15 December 2022

**PROPOSED VHUVHILI GRID CONNECTION: RESPONSE TO SAHRA INTERIM COMMENT  
CASE ID: 20125**

**Figure 4:** SAHRIS Palaeosensitivity map showing the sensitivity based on geology to be zero over almost all of the project area. The remaining portion (inside black dashed circle) lies within the Vhuvhili PV project site which has already been approved by SAHRA.

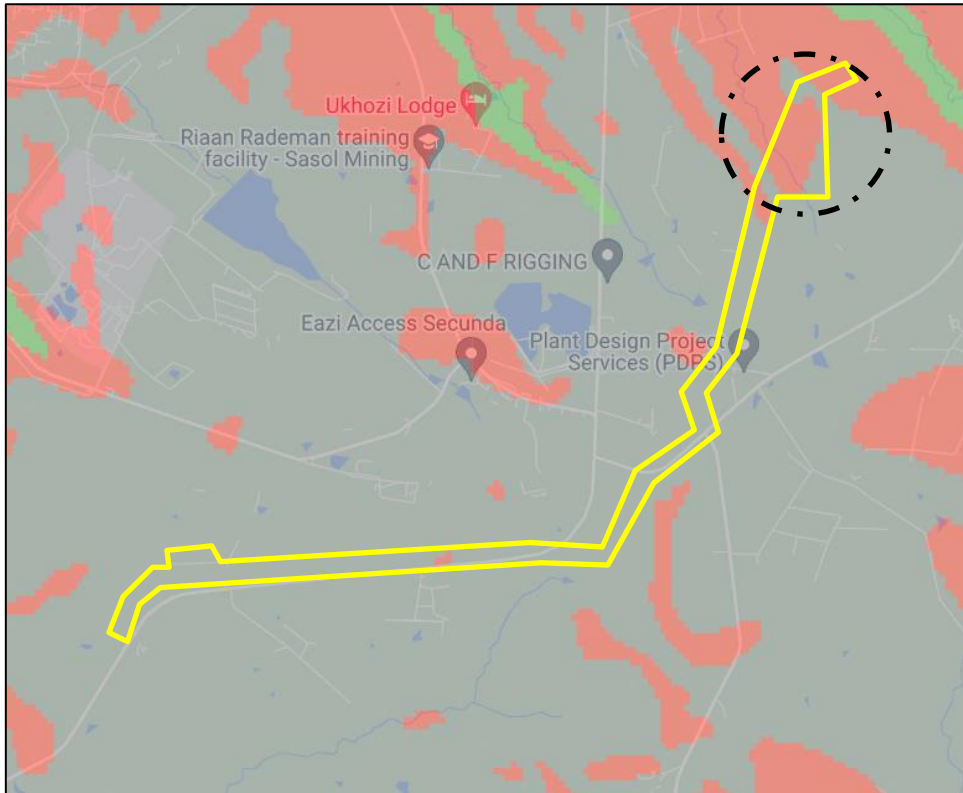
As shown by the SAHRIS Palaeosensitivity map (Figure 4), almost the entire site lies over geology of zero sensitivity which requires no assessment. This is Jurassic dolerite. The very small section in the northeast lies within the area of the proposed Vhuvhili PV project which has been approved by SAHRA. The same comment was raised by SAHRA for that project but, based on the complete lack of rock outcrops on the sandy surface with estimated palaeosensitivity being based solely on drill cores, SAHRA accepted that a specialist field survey was pointless. Given that the relevant area was assessed in the Vhuvhili PV reporting there seems no reason for SAHRA to offer a different opinion now.
